Response to Submissions and Amendments to Proposed Development

Building R4A (SSD 6964)

Barangaroo South

Submitted to Department of Planning and Environment
On Behalf of Lend Lease (Millers Point) Pty Ltd

Figure 1 – Design Guidelines Building Mass and Location diagram
Source: *Barangaroo South Built Form and Urban Design Guidelines*

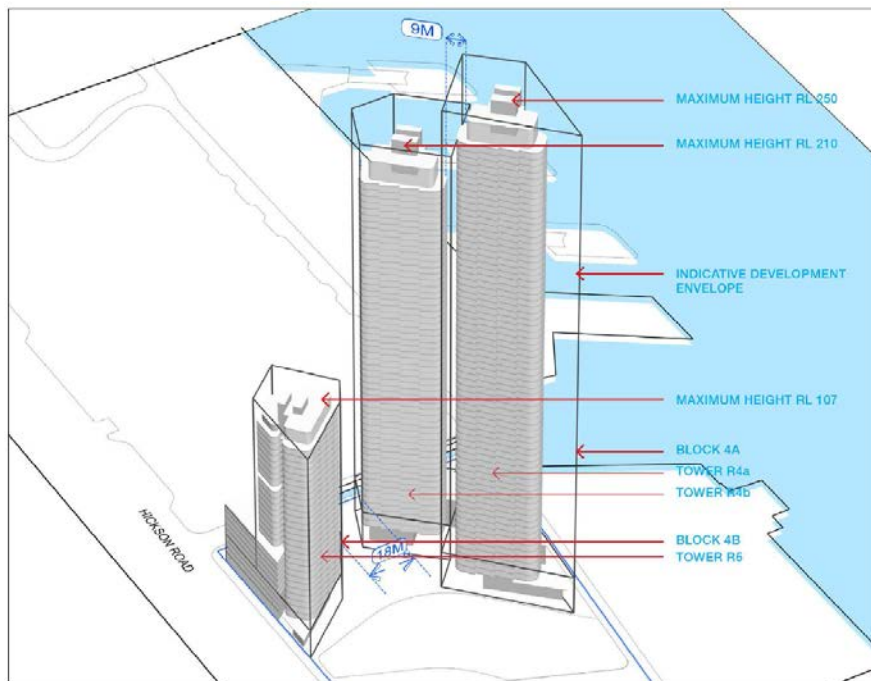
In particular, the Department has requested that a further assessment is provided on the proposal's consistency with the *Barangaroo South Built Form and Urban Design Guidelines* ('the Guidelines') in relation to the design of the podium. The Department has confirmed this request largely relates to Building R5, but should be addressed for all three buildings. The Council noted concern that the design of the building did not include elements to minimise building bulk or wind impacts and that the proposed built form would prevent the establishment of a consistent street wall along Hickson Road.

An extract from the Design Guidelines is reproduced at **Figure 1** to demonstrate that the height of the podium has been carefully designed in accordance with these guidelines, whilst **Figure 2** provides a detailed diagram of the building envelope which has guided the built form.

Figure 8 – Ground Floor Permeability and Accessibility of Public Realm diagram
Source: Barangaroo South Built Form and Urban Design Guidelines

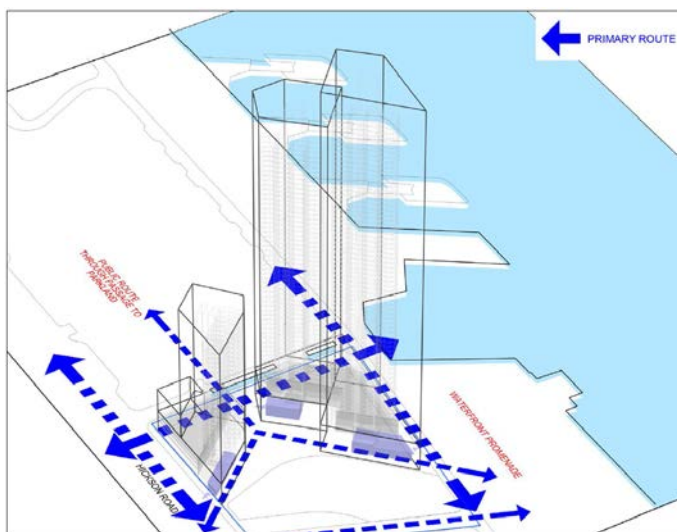
Concern was also raised by Council on the design of the Strada in relation to public accessibility and urban design considerations. The Department has requested further details on this element of the proposal.

Figure 8 shows an extract from the Design Guidelines, which demonstrates the primary access routes around Block 4A and Block 4B. Control 5 provides objectives and standards to achieve ground floor permeability and accessibility of the public realm, including:

Primary north-south access routes are provided along Hickson Road and Barangaroo Avenue, in accordance with the Design Guidelines, whilst the Strada achieves the standards outlined in Control 5 of the Design Guidelines as it provides a secondary north-south connection through Block 4A. The Strada, through the use of high quality glazing, also facilitates visual and physical permeability by allowing pedestrians to easily navigate between Hickson Park and Watermans Quay.

Figure 11 – Achievement of cross ventilation on a typical floor plate between Levels 4 - 7
Source: RPBW

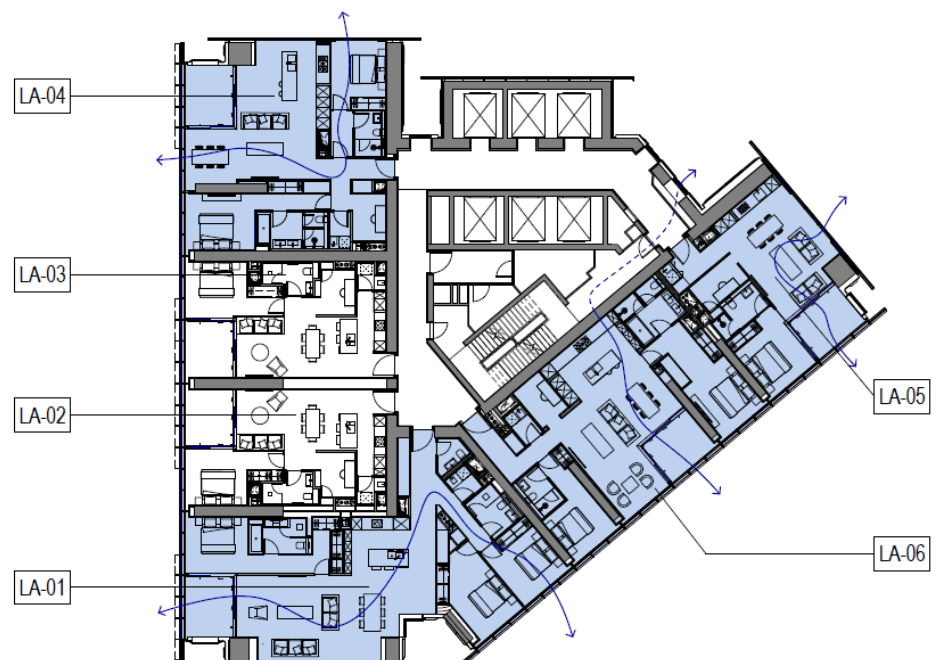
It was requested by the Department that detailed information be provided to demonstrate how cross ventilation is achieved, including detailed diagrams. In particular, it was noted that cross ventilation from corridors should not be counted and that wintergardens should not be permanently enclosed.

Figure 11 shows the achievement of cross ventilation on a typical floor plate and further detail is provided in the Supplementary Design Report at **Appendix C**.

In addition to this, the wintergarden glazing system has a minimum fixed opening of 150mm to ensure that the wintergardens can never be fully enclosed. This ensures that cross ventilation is maximised, capturing breezes from Sydney Harbour and Hickson Park below.

Figure 12 – Building separation
Source: RPBW

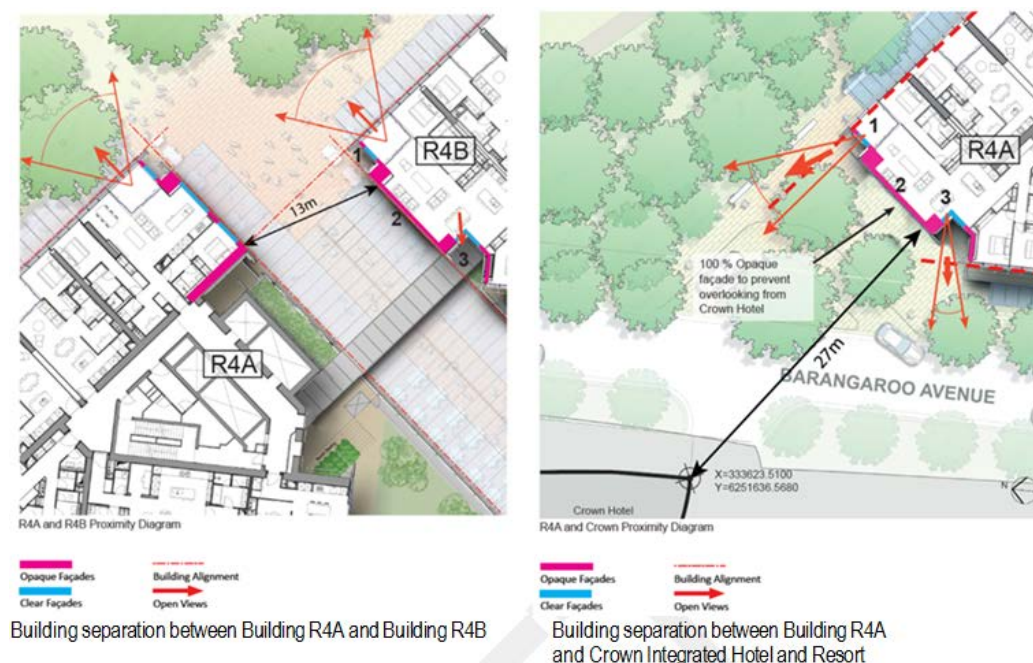
It was noted by Council that the proposed building separation is less than the design criteria set out under Objective 3F-1 of the ADG and that providing such separation is important to protect visual and acoustic privacy as well as to achieve a high level of amenity for future residents.

The Supplementary Design Report at **Appendix C** provides detailed diagrams demonstrating the separation between each building and design measures that have been incorporated to maintain visual privacy. **Figure 12** shows the relationship of Building R4A to Building R4B and the future Crown Integrated Hotel Resort. The separation distance between Building R4A and the Crown Integrated Hotel Resort is 27 metres and thus exceeds the maximum building separation suggested under the design criteria of Objective 3F-1 of the ADG.
